Proposal #10: 2415-00-70, WISC 2017 268
South 60th Street
W Cold Spring Rd to W Morgan Ave
Local Street
Milwaukee County

This is Addendum No. 01, which provides for the following:

ADDENDUM NO. 01

2415-00-70

Addendum No. 01
ID 2415-00-70
Revised Sheet 49
April 28, 2017

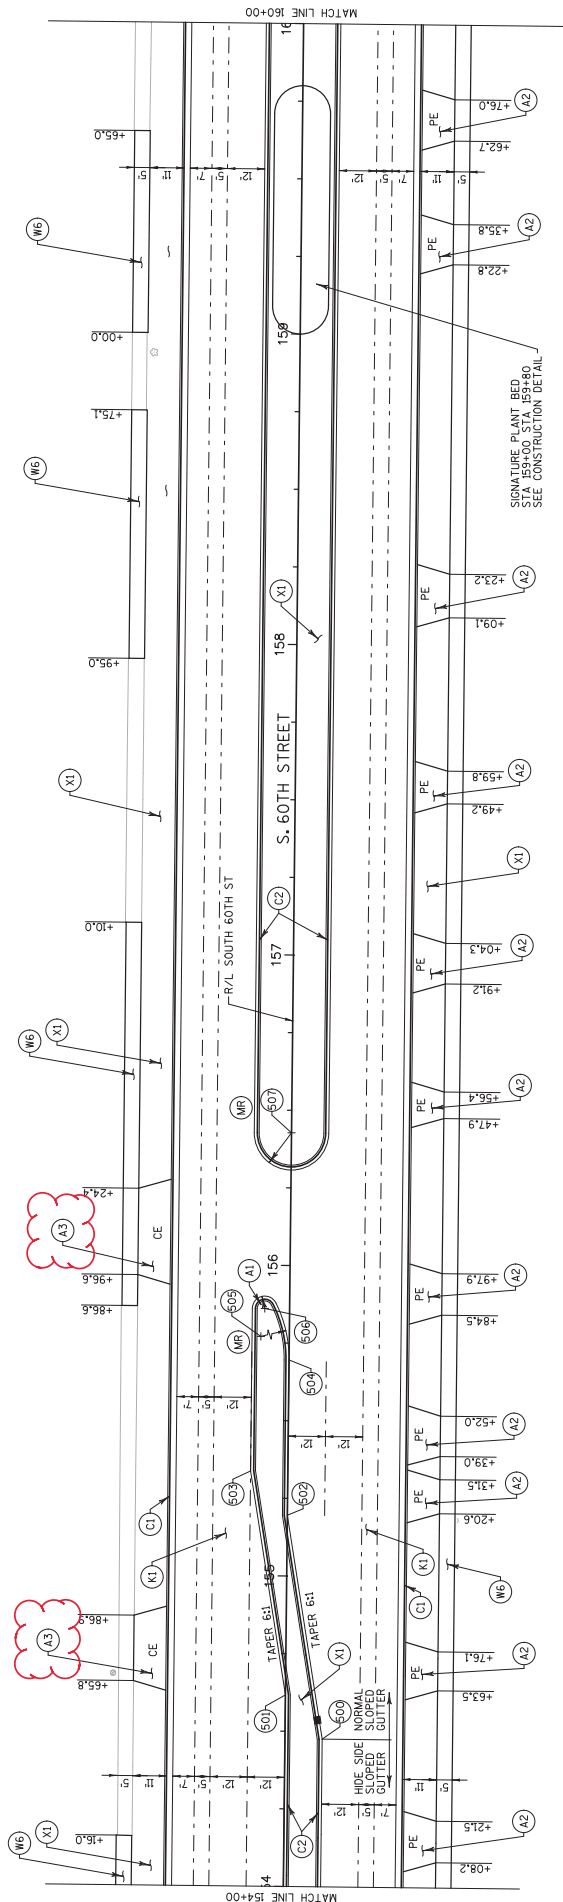
Revised Plan Sheets	
Plan Sheet	Plan Sheet Title (brief description of changes to sheet)
49 - 50	Plan Detail Sheets (Modify three driveways from 7-Inch Concrete to 8-Inch Concrete)
170	Miscellaneous Quantity (Modify Concrete Driveway Quantities)
